Re: #1603 - #1605 Main Street

Allen Engineering & Associates, Inc. (AEA) has received a peer review letter from Quinn Engineering, Inc. dated October 25, 2021 related to the site plan application for the above referenced property. Below please find the original comments along with our (AEA) responses.

TITLE:  
**GRADING & DRAINAGE  
PLAN**  
For  
**#1603 - #1605 Main Street**  
In  
**Leicester, MA**

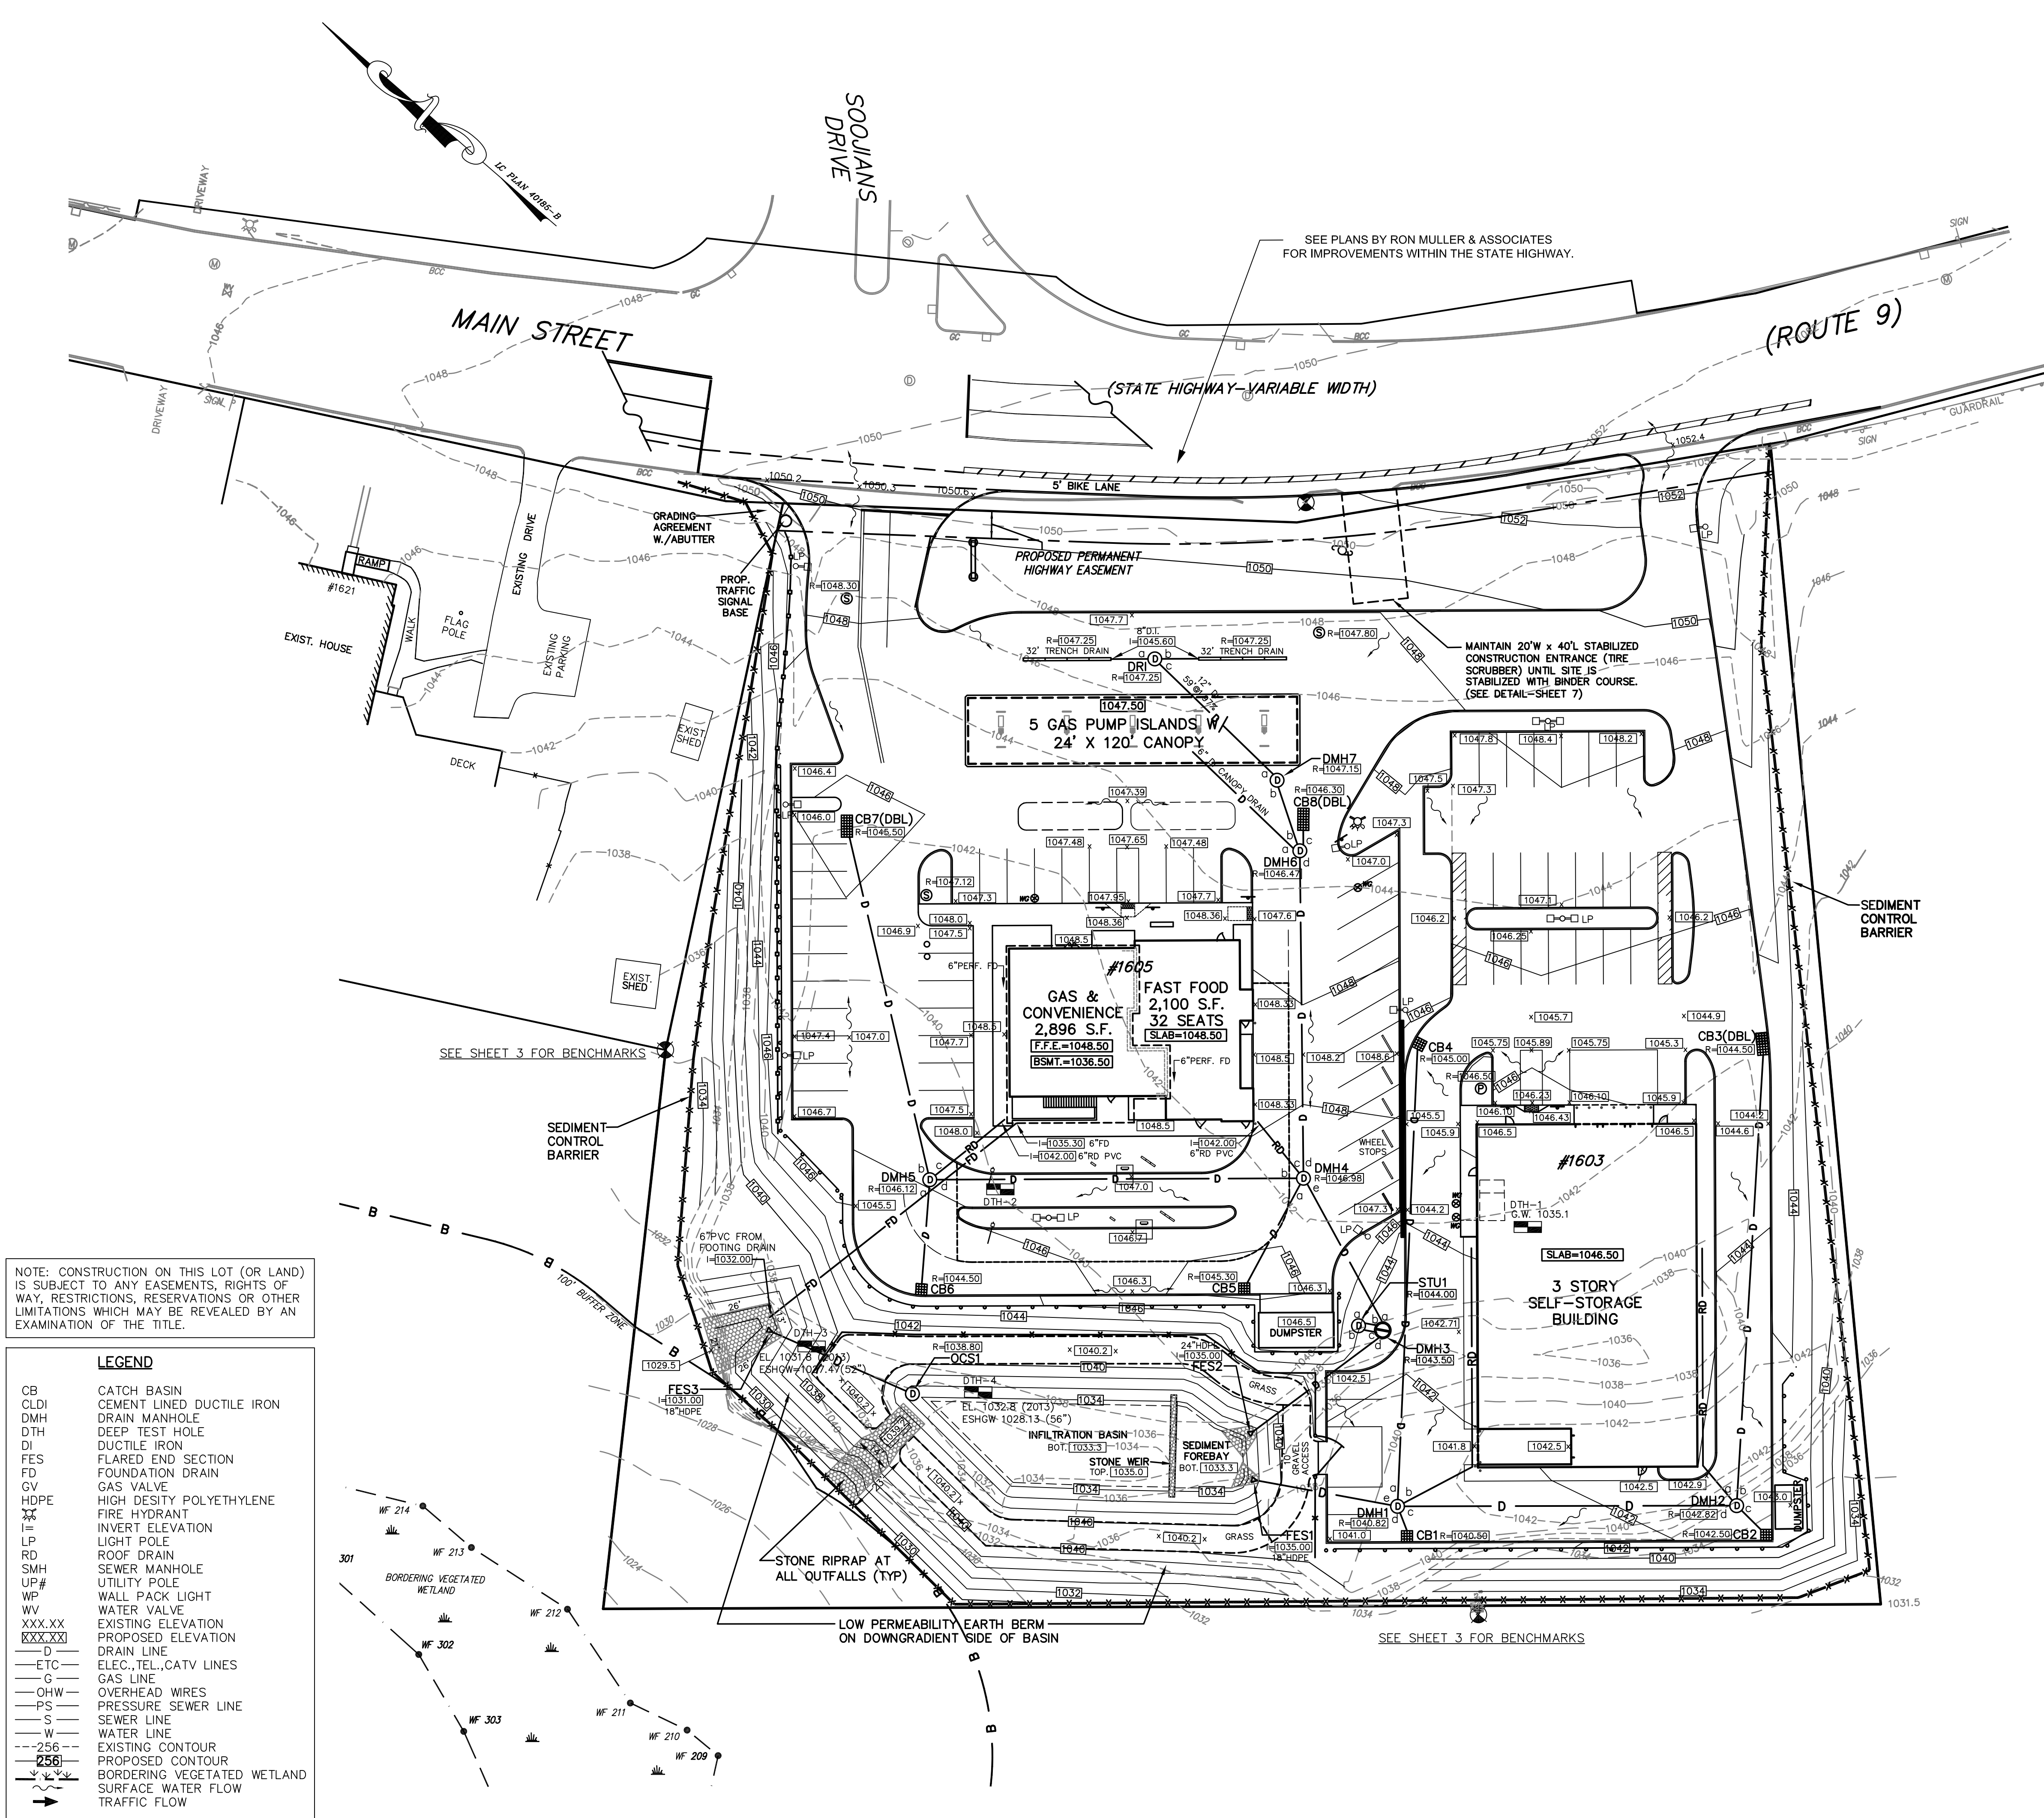
21. Catch basins are to be designed as off-line systems. The proposed outlet from DRI should be rerouted to a manhole instead of discharging to CB8. DRI should also be provided with a hood on the outlet to capture oil and floatables. (MA DEP Handbook Vol. 2, Ch. 2, page 3-5)  
*AEA- Due to shallow ledge conditions a sump structure in the area of DR1 is not feasible. DR1 functions as both an inlet and a junction/cleanout for the proposed trench drains. The site plan and calculations have been revised to route this structure to a new sump manhole with trap (DMH7).*

33. It appears that the invert and rim elevations listed for CB7 in the drain schedule are mislabeled.

AEA- *Labels have been corrected.*

**PIPE END RIPRAP APRON**  
(NOT TO SCALE)

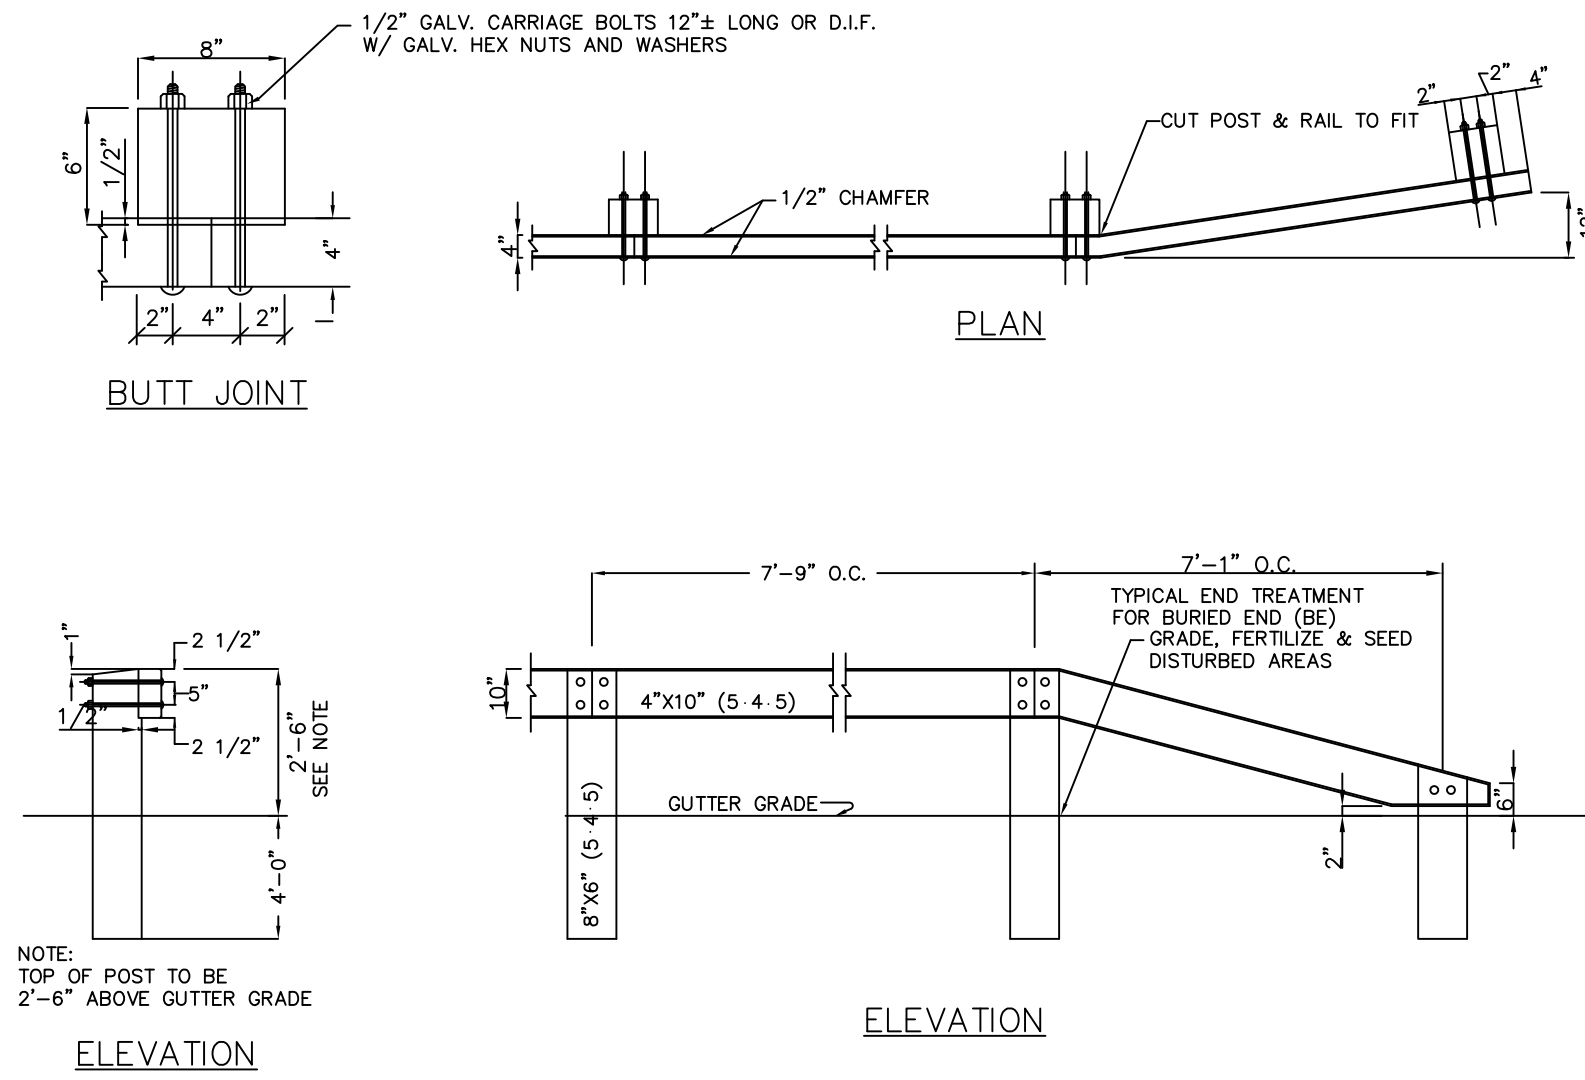
18. The dimensions of the rip rap aprons must be provided. Calculations supporting the dimensions should also be provided. (MA DEP Standard 1)

AEA- *Rip rap detail added to sheet 10.*

**WOODEN GUARD RAIL**  
(NOT TO SCALE)

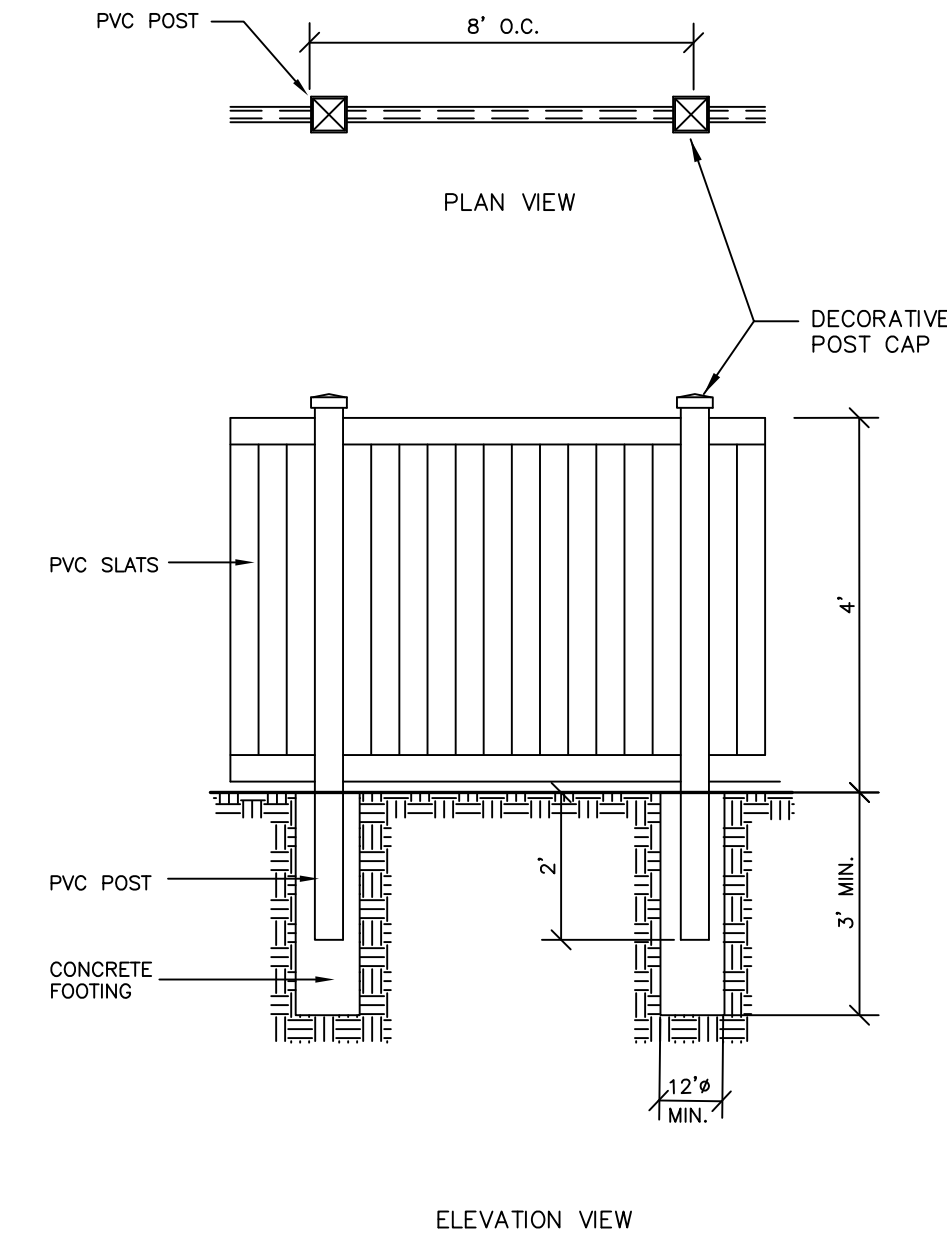
31. Details should be provided for several site related items (ie. guardrails, fences, bollards, retaining wall, curb stops, etc.).

32. A guardrail is recommended on the top of the retaining wall in lieu of a fence. This office's experience has been that wheel stops, like those currently proposed, tend to get damaged over time and are removed. In that case, a guardrail would be a better option along the top of the wall.

AEA- *Water infrastructure (curb stops, etc.) will be installed in compliance with the Leicester Water Supply District standard details. Guardrail and fence detail added to sheet 10. Retaining wall details will be provided to the building department during building permit application, if required.*

**PRECAST CONCRETE DIVERSION MANHOLE**  
(NOT TO SCALE)

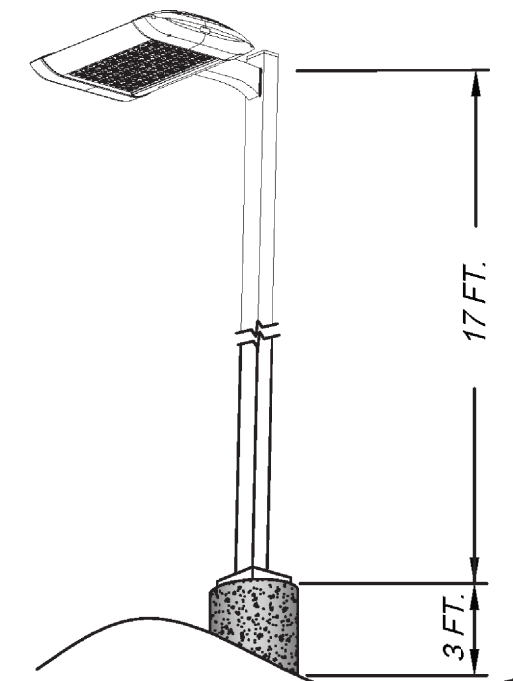
34. The weir elevation and inlets/outlet elevations must be labeled in the diversion manhole detail.

AEA- *Labels added.*

LIGHTING  
PHOTOMETRIC PLAN

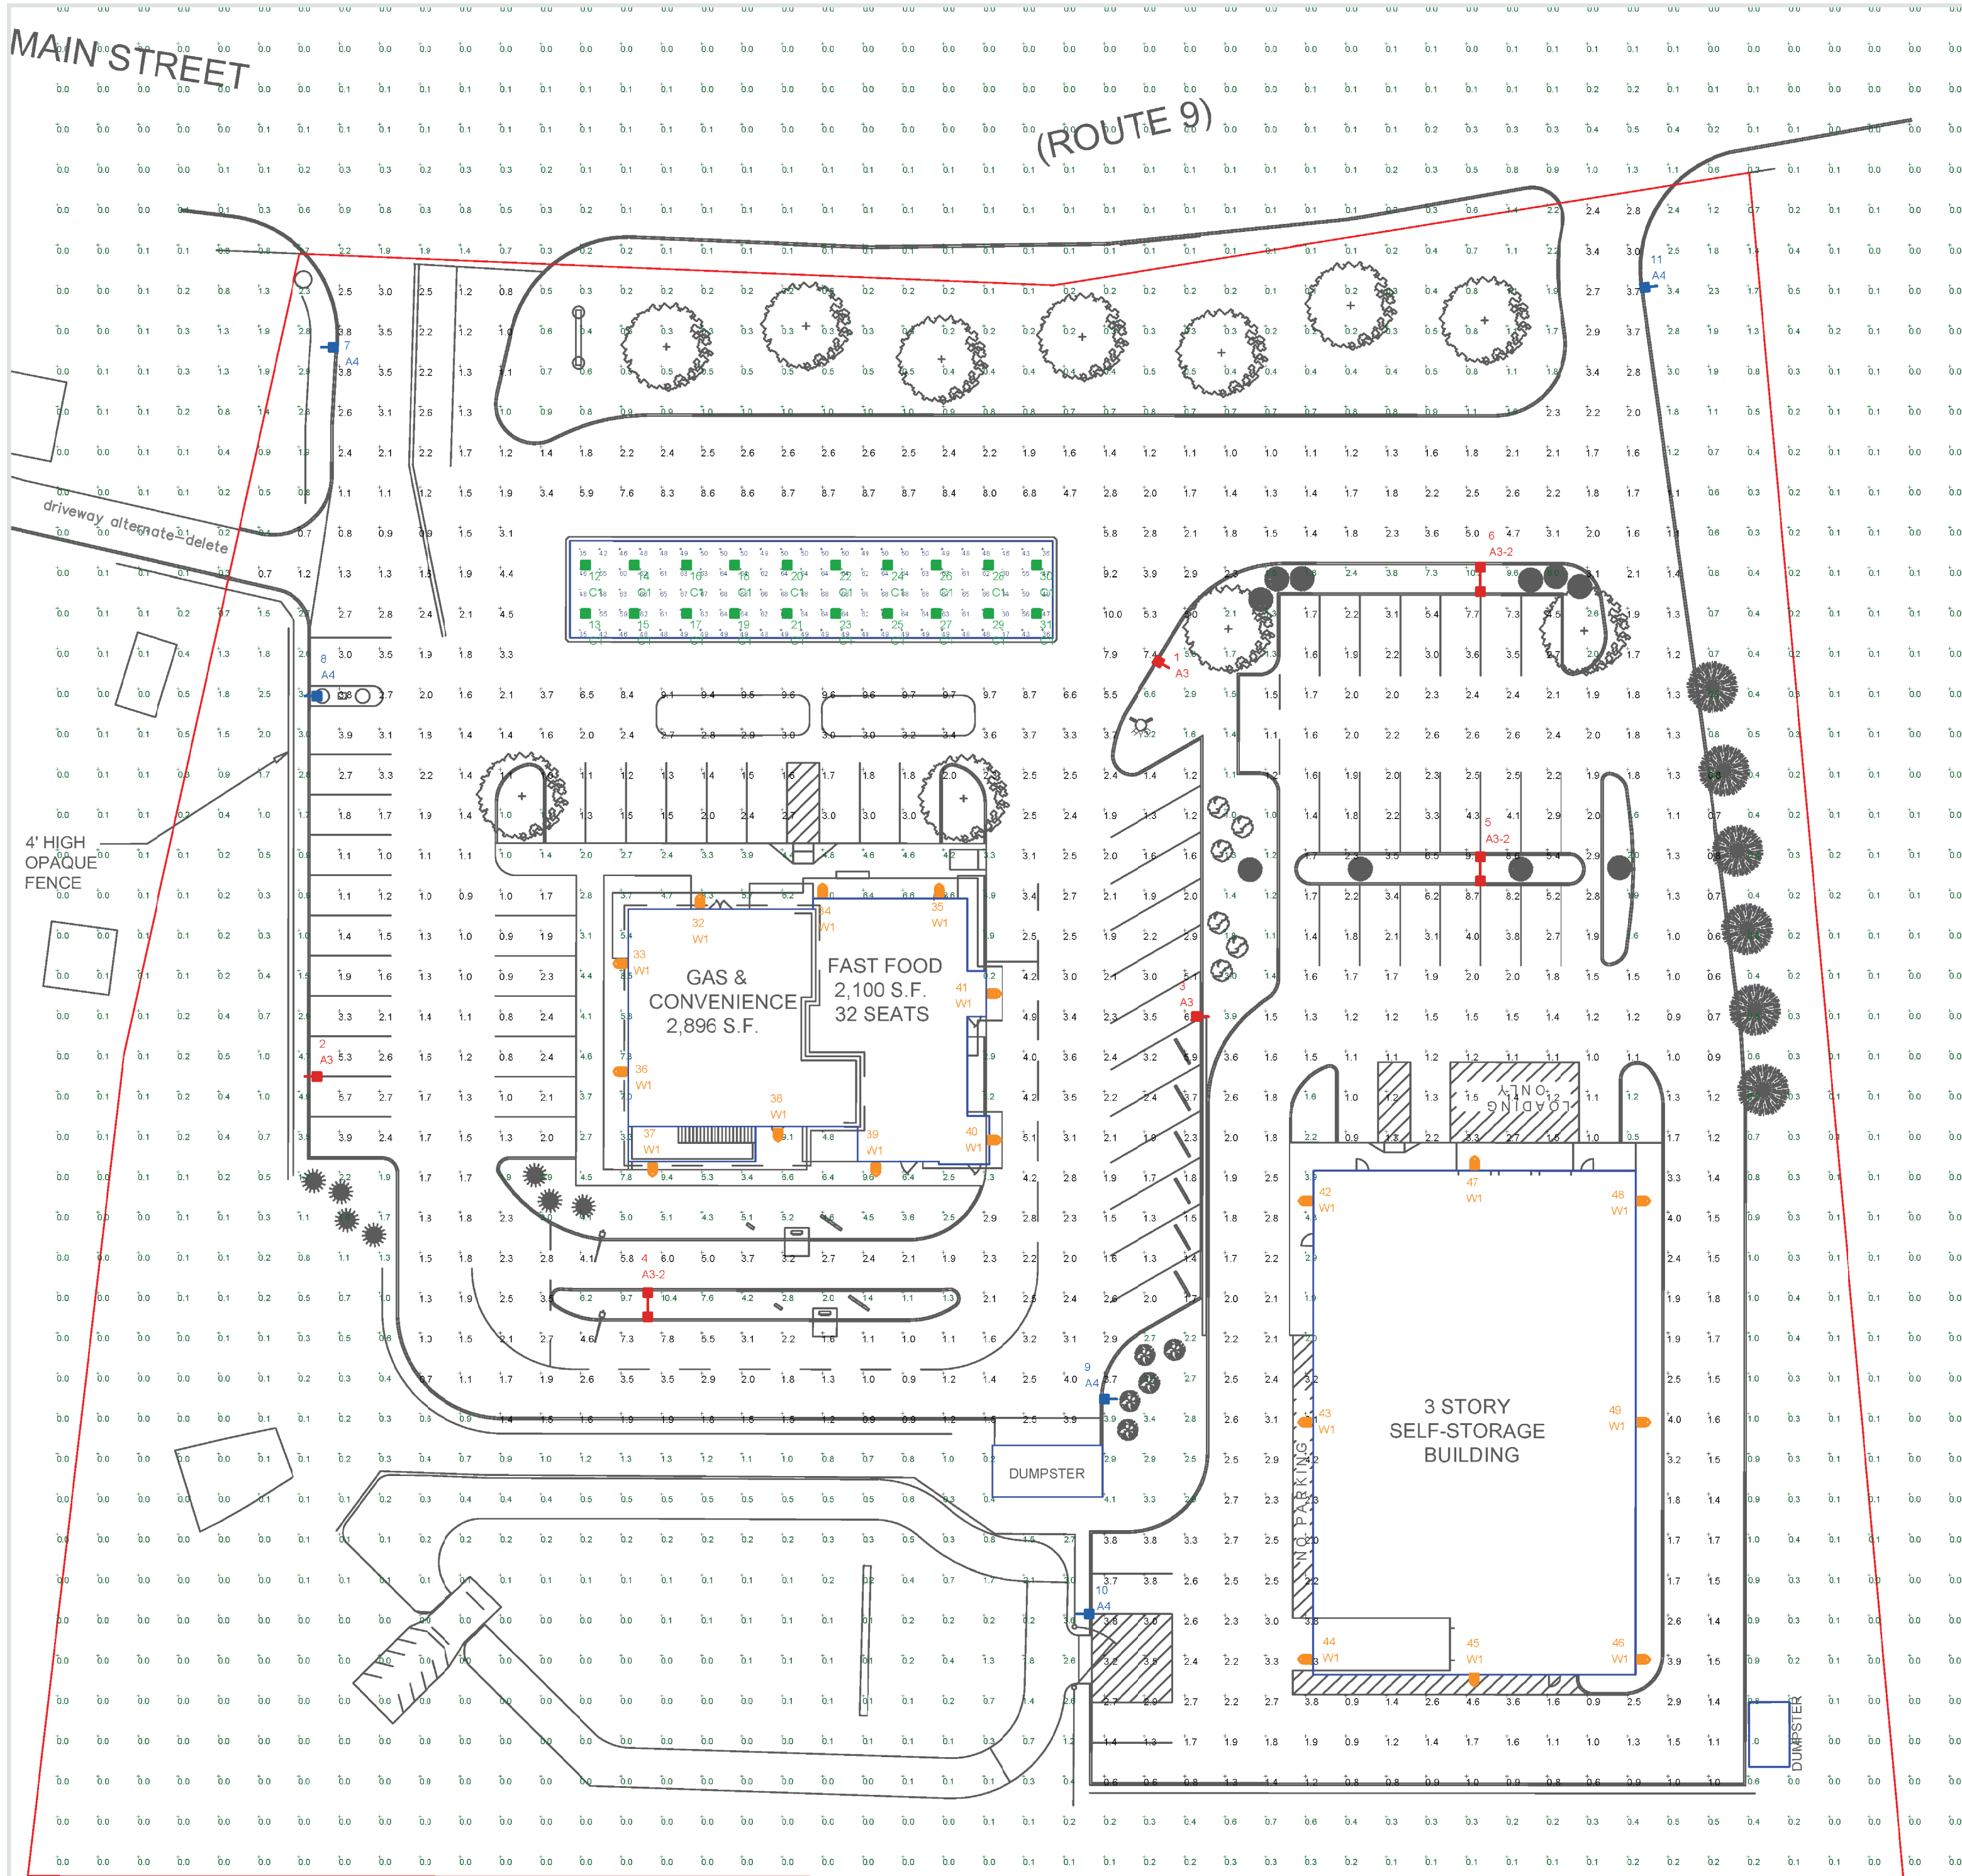
5. The submitted photometric plan identifies light spillage over 1 foot-candle on the adjacent property. The Applicant must demonstrate that lighting does not shine beyond the property lines. (§5.5.02.1.A.7 and LPR IV.G)  
AEA- *A wooded area near the entrance/new traffic light installation approximately 125 feet from the existing building is shown to have a small area of over 1 foot-candle due to the proximity of the light that illuminates the project entrance. AEA defers to the Board as the cited regulations do not provide a maximum foot-candle measurement.*
